# Autoclass reference time v100

## Info (not part of baseline)

Figure 145–14—PSE Autoclass state diagram

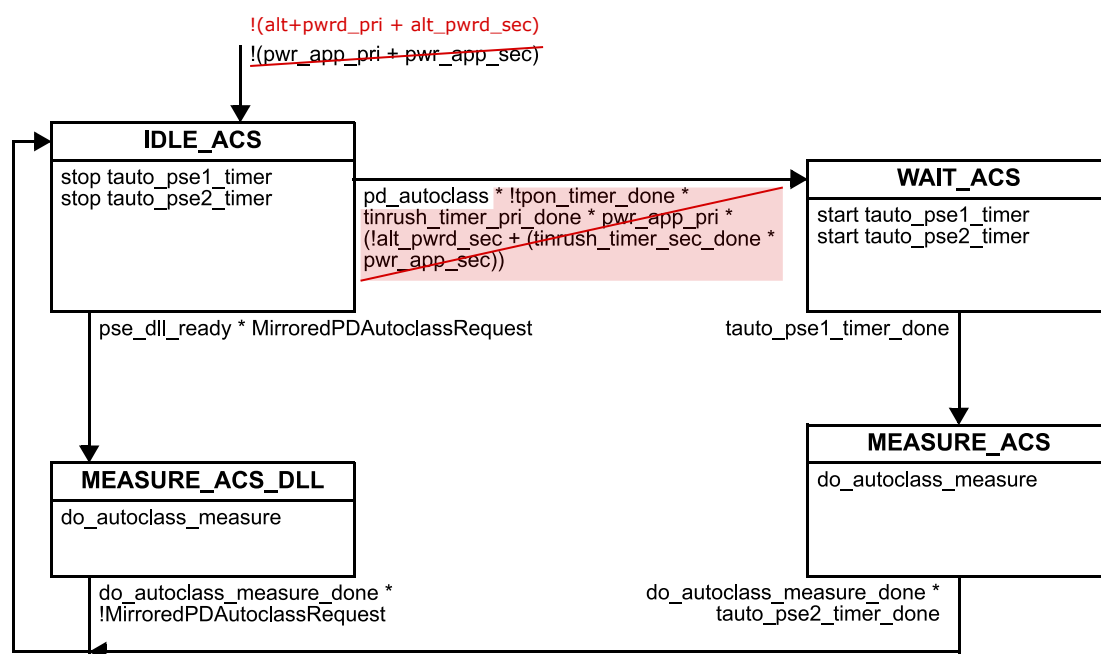
The Autoclass measurement time for the PSE (defined by  $T_{\text{AUTO\_PSE1}}$  and  $T_{\text{AUTO\_PSE2}}$ ) and the Autoclass maximum power draw time for the PD (defined by  $T_{\text{AUTO\_PD1}}$  and  $T_{\text{AUTO\_PD2}}$ ) is referenced from two different moments. The reference time for the PSE is “the transition of POWER\_UP to POWER\_ON”, where that for the PD is “measured when  $V_{\text{PD}}$  rises above  $V_{\text{Port\_PD-2P min}}$ ”. The PSEs time reference is not readily observable at the PI. This is unnecessarily complicated.

This baseline proposes to change both reference times to when  $V_{\text{PSE}}$  or  $V_{\text{PD}}$  crosses 30V. Regardless of what inrush scheme is used, this moment occurs near simultaneous for both devices and is observable at the PI. Timings can remain as-is.

Change Figure 145–14 as follows:

$T_{\text{AUTO\_PSE1}}$  and  $T_{\text{AUTO\_PSE2}}$  timing is referenced from ~~the transition of the POWER\_UP state to the POWER\_ON state~~ when  $V_{\text{PSE}}$  exceeds 30 V.

Figure 145–26—Single-signature PD Autoclass state diagram

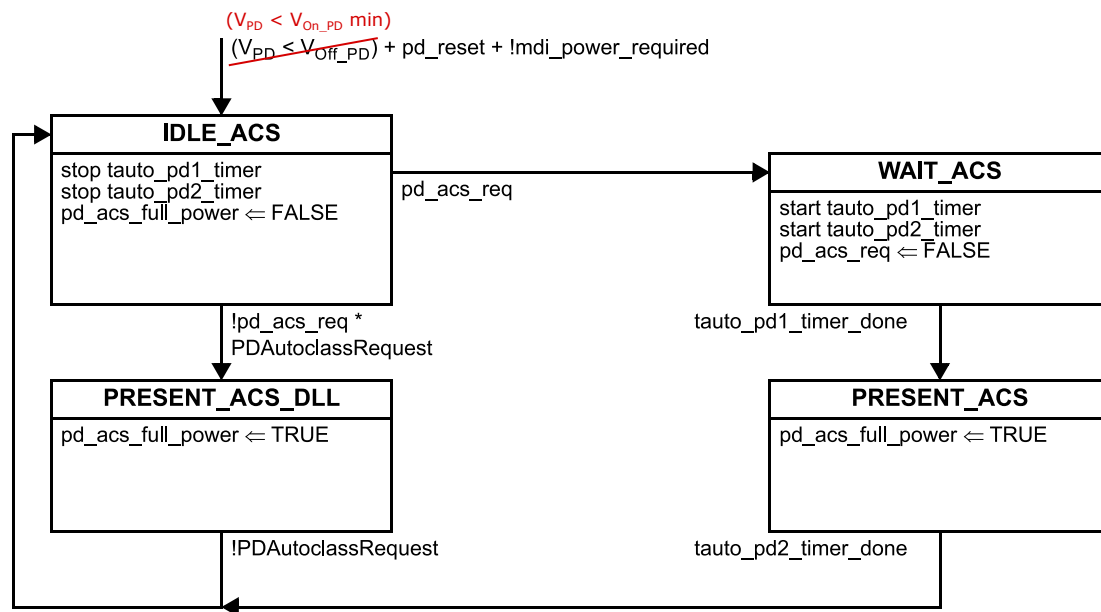
A final issue is that currently the PD state diagram does not agree with the PD Autoclass text. While the text uses  $V_{\text{Port\_PD-2P min}}$  as reference, the state diagram uses  $V_{\text{PD}} > V_{\text{Off\_PD}}$  as the reference point.

Change Figure 145–26 as follows:

After power up, a PD that implements Autoclass shall draw its highest required power,  $P_{Autoclass\_PD}$ , subject to the requirements on  $P_{Class\_PD}$  in 145.3.8.2, throughout the period bounded by  $T_{AUTO\_PD1}$  and  $T_{AUTO\_PD2}$ , measured from when  $V_{PD}$  rises above  ~~$V_{Port\_PD-2P\ min}$~~   $V_{On\_PD\ min}$ .
